Unless otherwise specified, all values are as follows: resistor values are in Ohms, i.e. 0R47, 5R6, 220, 5K6, 22K capacitor values are in Microfarads, i.e. 220p, 0u1, 2u2, 33 inductor values are in Microhenries, i.e. 0u22, 5u6, 68, 2m2		PCB Name: <i>N/A</i>				Title: Forum Dual LNG Reglerteil			
		PCB Nr.: <i>N/A</i>				Used in			
This drawing is our property. Duplication, unauthorized use of any kind is prohibited. Without Approval use only for inquiry.		Approval:		PCB Type:		Scale:		Repl. for	
		Date		Name		Date		Name	
Drawn		7-Nov-2018		GJO				Prj. Nr. 13036	
Modified								Size: A3 Rev: 1.03	
Checked								Drw. Nr. 4415-XXXX	
<input type="checkbox"/> Prototype <input type="checkbox"/> Production <input type="checkbox"/> BOM Done?								File: <i>ForumLNG_BOARD_V103.sch</i>	
								Sheet 1 of 1

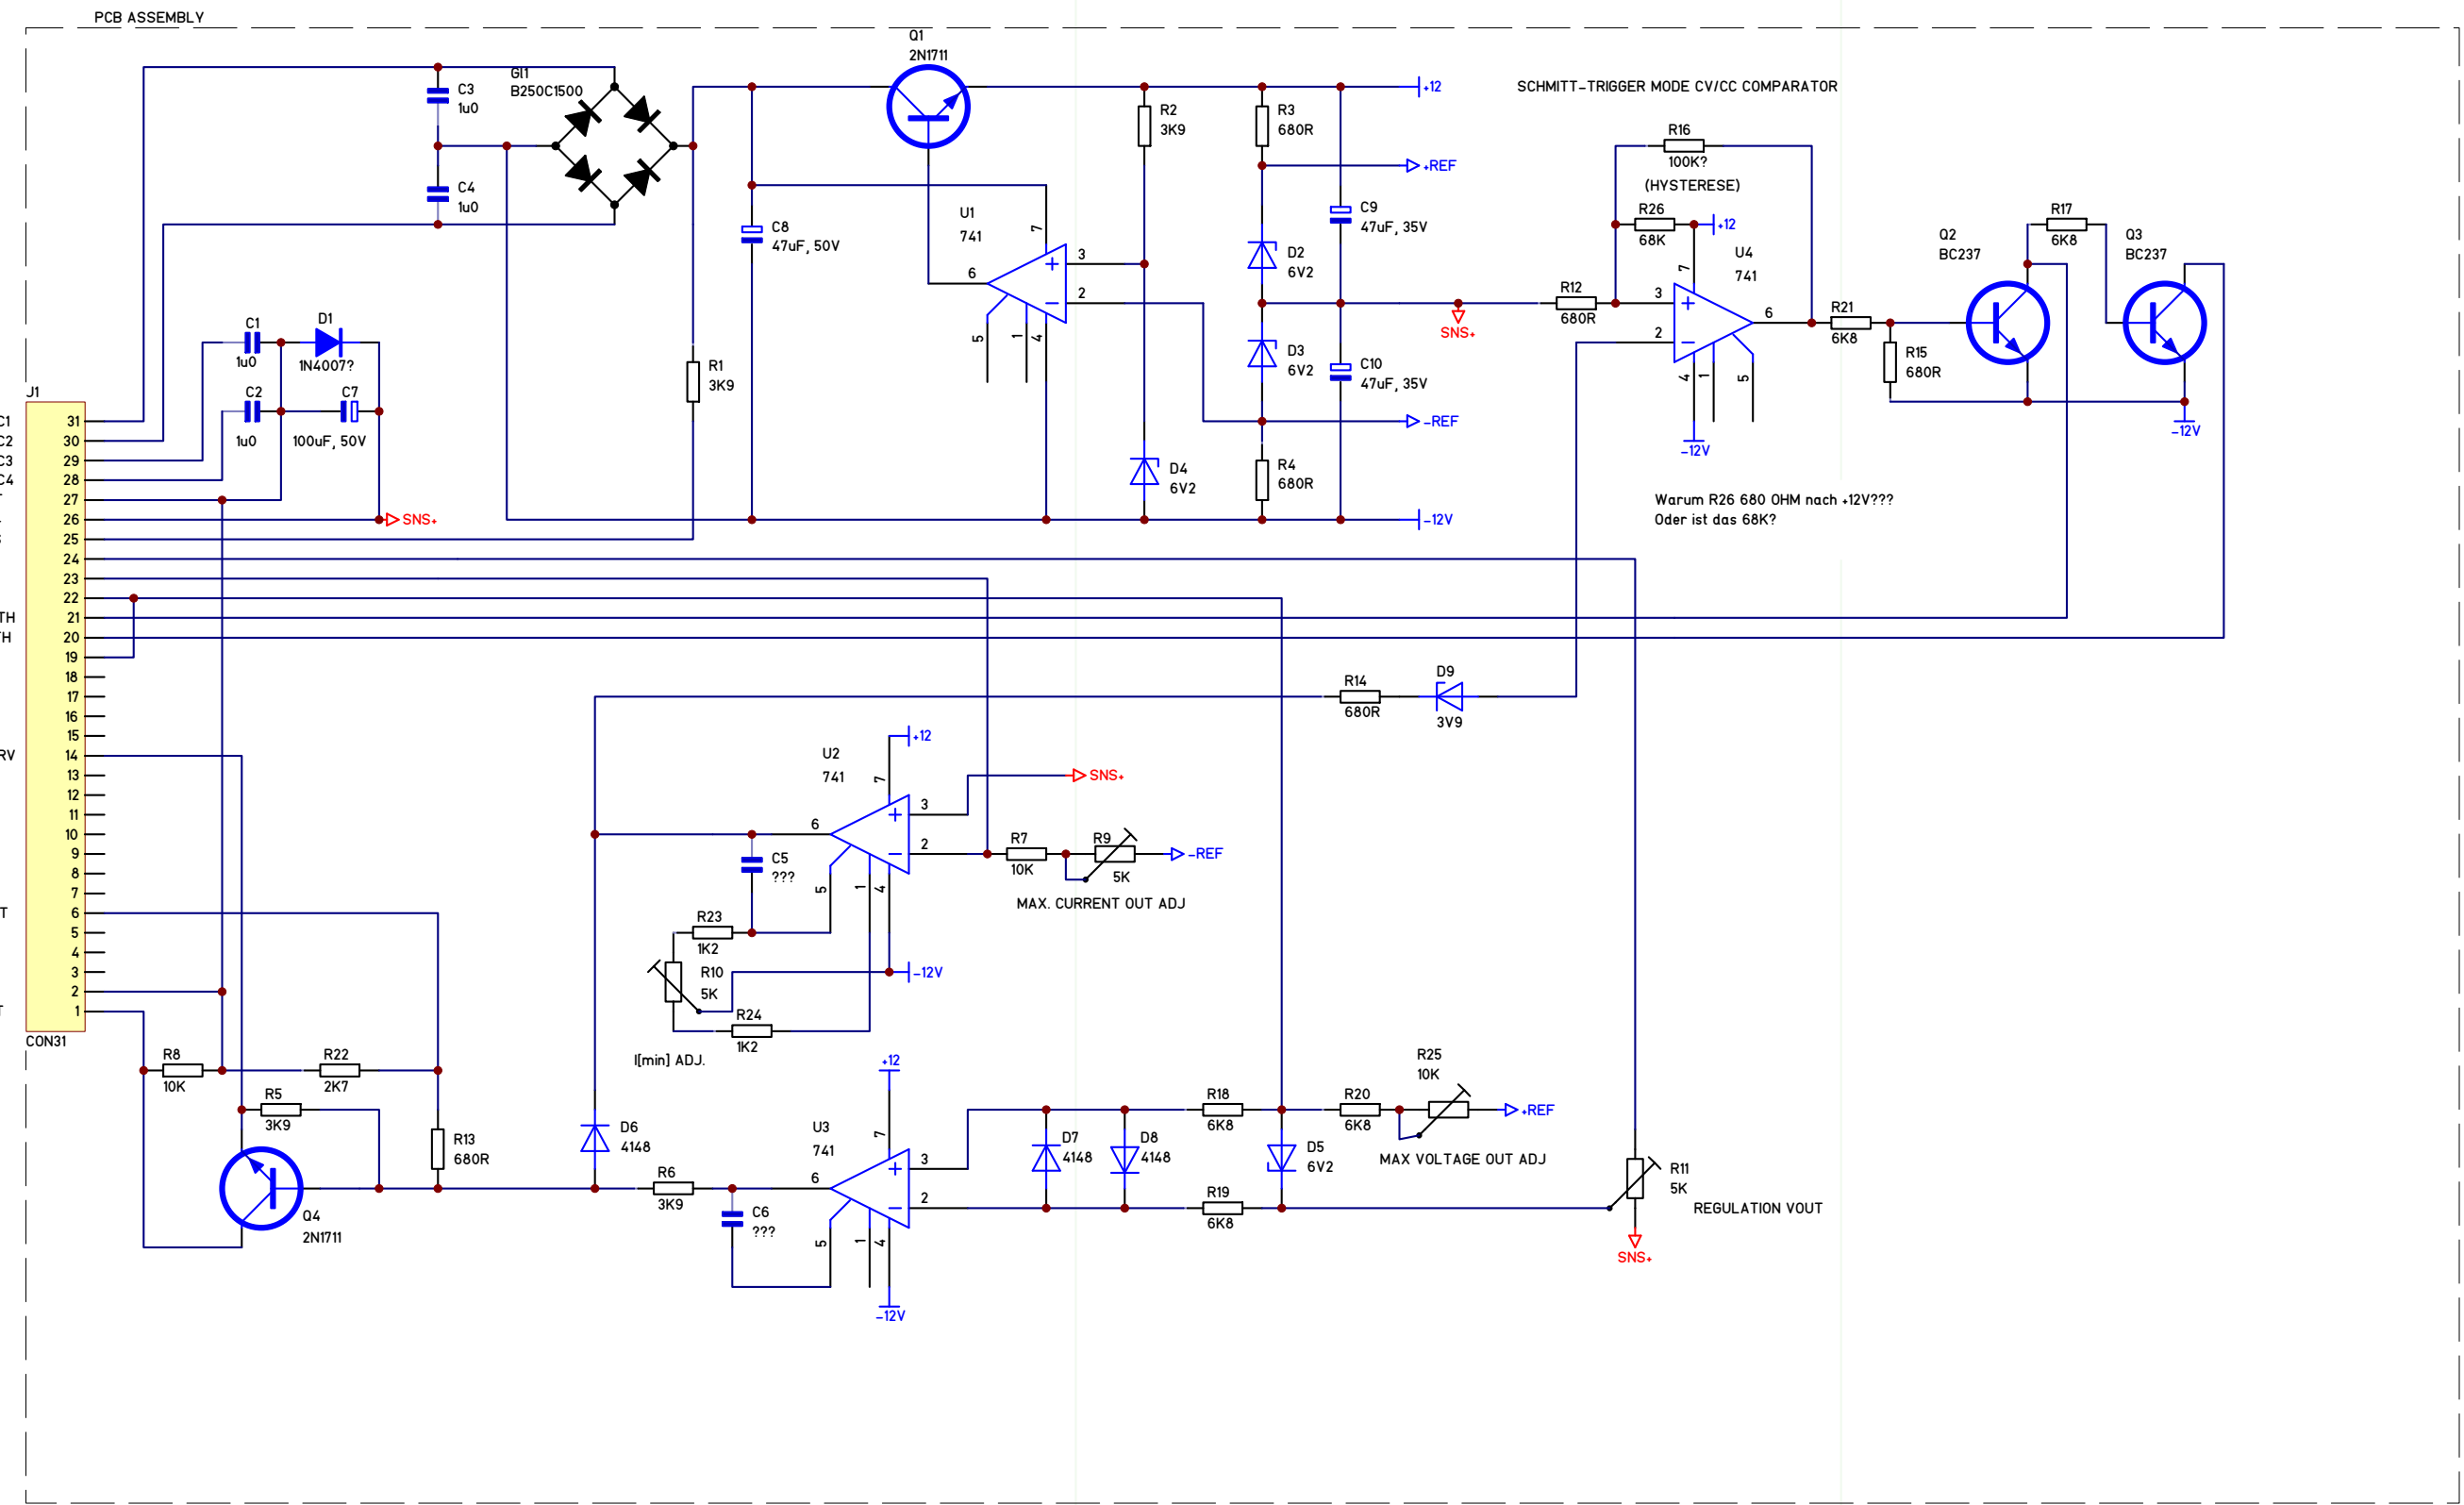
Warum R26 680 OHM nach +12V???
 Oder ist das 68K?
